**NORTHEAST UTILITIES**

Docket No. 50-423  
A04078

Millstone Nuclear Power Station, Unit No. 3  
Response to Requests for Additional Information

NRC Letter May 25, 1984

FIGURE Q480.37-1  
 UPPER REACTOR CAVITY  
 NODAL ARRANGEMENT  
 MILLSTONE NUCLEAR POWER STATION  
 UNIT 3  
 FINAL SAFETY ANALYSIS REPORT

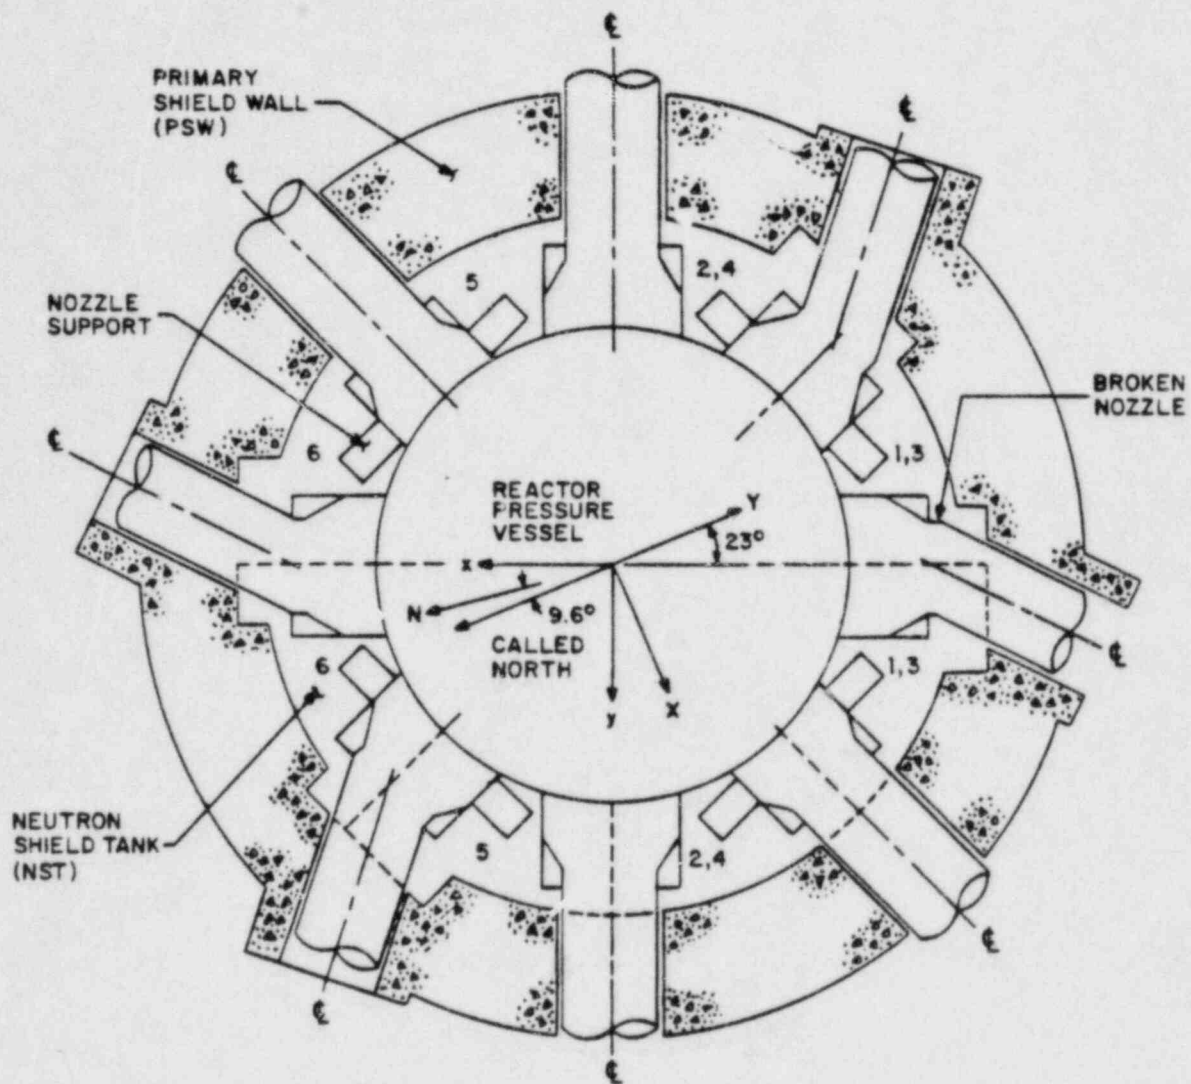
In the unlikely event of a pipe rupture inside a major component subcompartment, the initial blowdown transient would lead to nonuniform pressure loadings on both the structure and the enclosed component(s). To ensure the integrity of these design features, we request that you provide the following information for each subcompartment analyzed:

- a. Provide the peak and transient loadings on the major components used to establish the adequacy of the supports design. This should include the load forcing functions [e.g.,  $f(t)$ ,  $f_x(t)$ ,  $f_y(t)$ ] and transient moments [e.g.,  $M(t)$ ,  $M_x(t)$ ,  $M_y(t)$ ], as resolved about a specific, identified coordinate system. 1.12

1.19  
~~1.21~~
- b. Provide the projected area used to calculate these loads and identify the location of the area projections on plan and section drawings in the selected coordinate system. This information should be presented in such a manner that confirmatory evaluations of the loads and moments can be made. 1.22

• [ Reactor Nozzle Guillotine	1.55
<u>Configuration</u>	2.1
Figures Q480.37-1 and Q480.37-2 show the reactor cavity geometry for the postulated break at the inlet nozzle from Reactor Coolant Loop 2 (Cubicle B). The global coordinate system is defined as follows:	2.2 2.3 2.4
Origin - on containment centerline and 17 feet-6 inches below reactor nozzle centerlines	2.8 2.9
X - horizontal, south 80.4° west	2.10
Y - horizontal, south 9.6° east	2.11
Z - vertical upward	2.12
The local coordinate system is chosen, as shown in these figures, so that local x points from the RPV centerline away from the broken nozzle. Therefore, vertical forces will be aligned with local z (= global Z), horizontal forces will be aligned with local x, and overturning moments will be about the local y axis. Other loading components due to the slight asymmetry of the RPV nozzle layout are ignored.	2.16 2.17 2.18 2.20 2.21
The nodal volumes for the asymmetric pressurization analysis, shown on Figures Q480.37-1 and Q480.37-2, also are assumed to be symmetric about the x-z plane. (See FSAR Figure 6.2-23 for overall nodal arrangement.)	2.22 2.23 2.24
